Engineering Change Notification

Harmonization of end plate adaption

Project No
229867

Project Title
DFM-B Harmonization
of end plate adaption

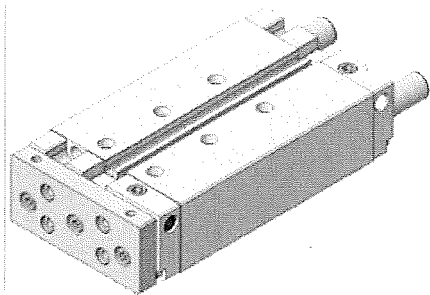
Optimize the connection between piston- and guiding rods in the same way we did for DFM. Now we fix the rods from the front with screws, instead of clamping-blocks for the guiding rods and nuts for the piston rod connection.

Connection between guiding rod and endplate via clamping blocks
Connection between piston rod and endplate via nuts+

Connection between guiding rod and endplate via screw from the front
Connection between piston rod and endplate via screw from the front
